## NOTIFICATION

#0008

**SUBJECT:** Potential risk of trim tab motor disconnecting from elevator skin

**MODELS AFFECTED:** All Sling aircraft delivered prior to October 2020

Figure 1: Ensure all four attaching screws are present

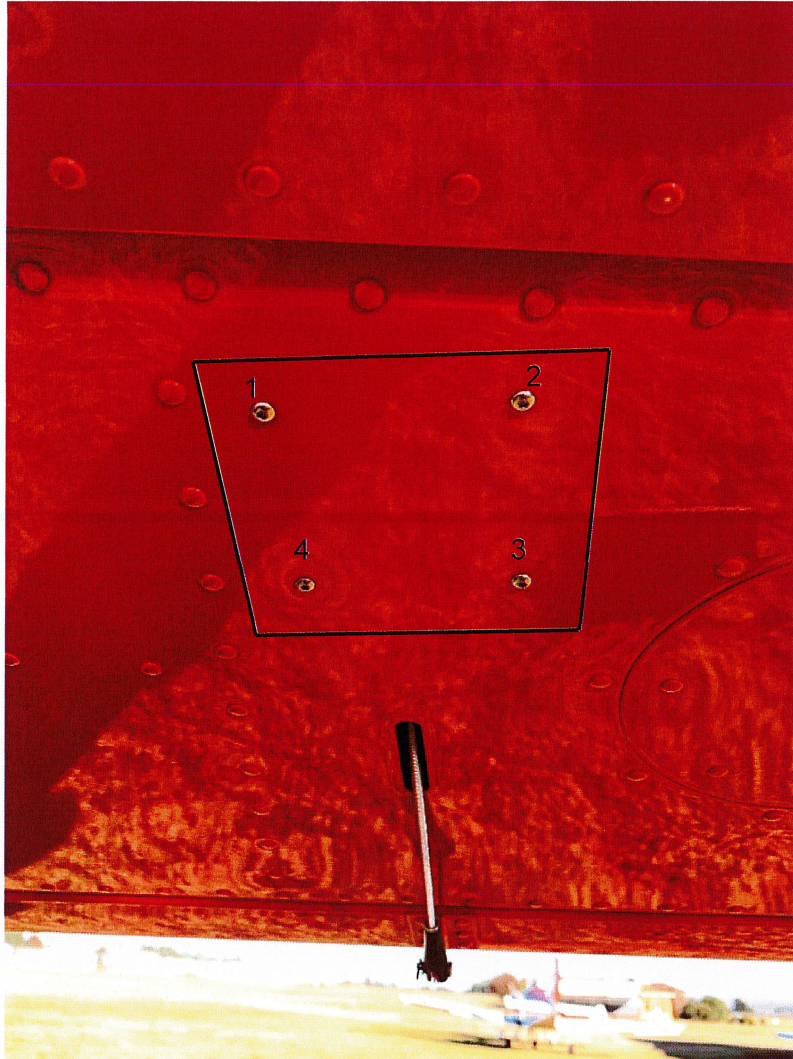
- a) The trim tab motor is secured to the elevator skin with four M3x10mm button head screws. Check that all four screws are present as shown in Figure 1.

- b) Missing screws must be re-installed with Loctite 222.
- c) In the unlikely event that missing screws result from rivnut failure (such as the rivnuts(s) breaking off from the trim motor flange), rivnuts must be replaced with 8-32 single lug anchor nuts, provided the trim motor flange is absent of damage that would prevent re-use.

- e) For aircraft produced after October 2020, the M3 rivnuts and M3x10mm button head screws have been superseded by 8-32 single lug anchor nuts and 8-32 x 1/2" stainless steel machine screws, respectively, to reduce the risk of trim motor disconnection.
